Proposal for amendments to Draft new Regulation on uniform provisions concerning the approval of enhanced Child Restraint Systems used onboard of motor vehicles

Submitted by the expert from France

The text reproduced below was prepared by the expert from France, on behalf of the informal working group on Child Restraint Systems. It is based on ECE/TRANS/WP.29/GRSP/2011/15. The modifications to the current text of the new ECE on Child Restraint Systems are marked in bold or strikethrough characters.

Replace Figure 0 (d) by drawing below

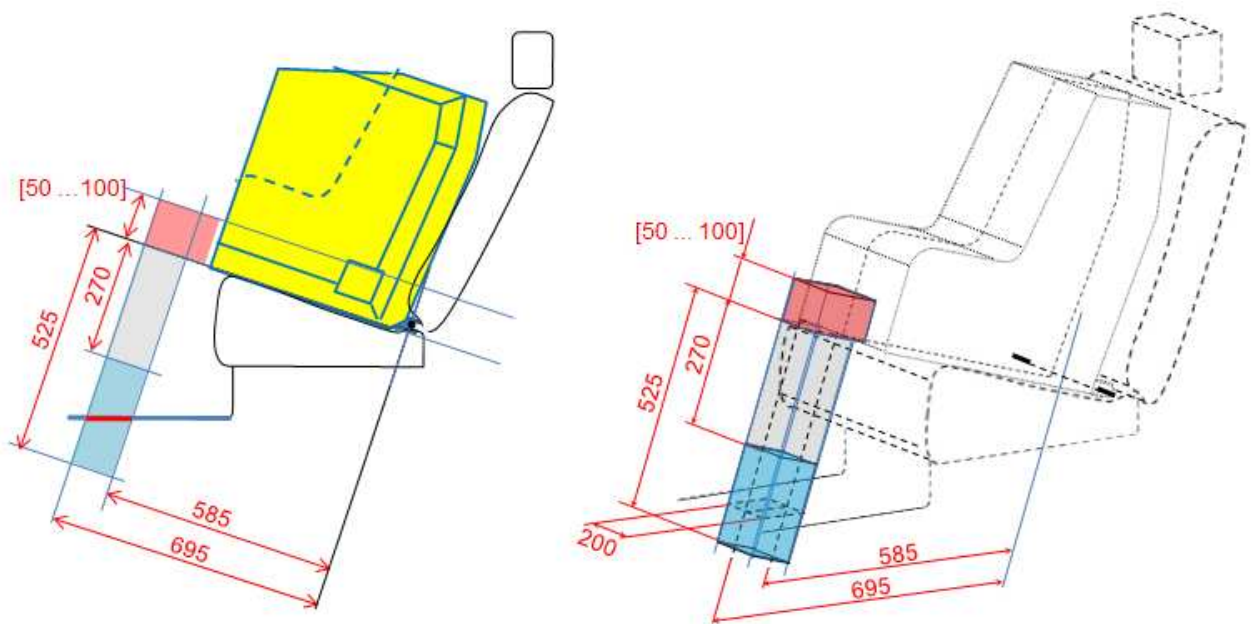
On paragraph 6.3.5.1., item (c) amend to read:
... [190] by **270mm** ...

On paragraph 6.3.5.1., item (d) amend to read:
... [490] by **525mm** ...

On paragraph 6.3.5.1., item (g) amend to read:
... [620] by **585mm** ...

On paragraph 6.3.5.1. item (h), amend to read:
... [820] by **695mm** ...

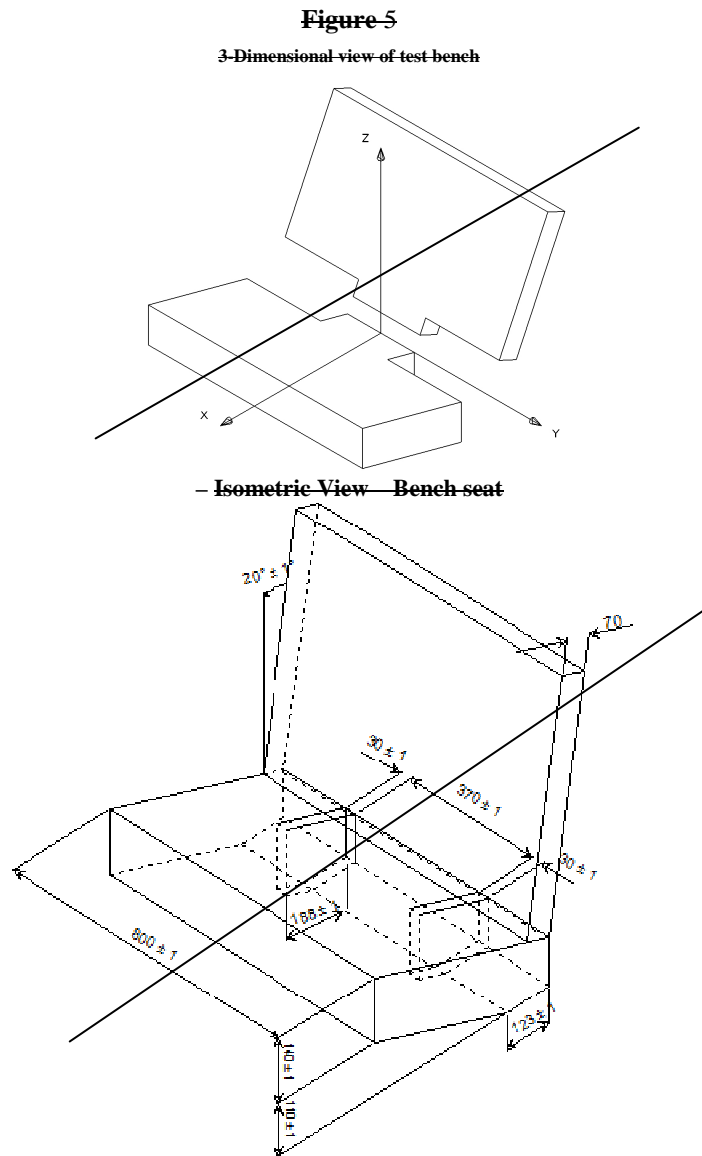
Delete the both drawings
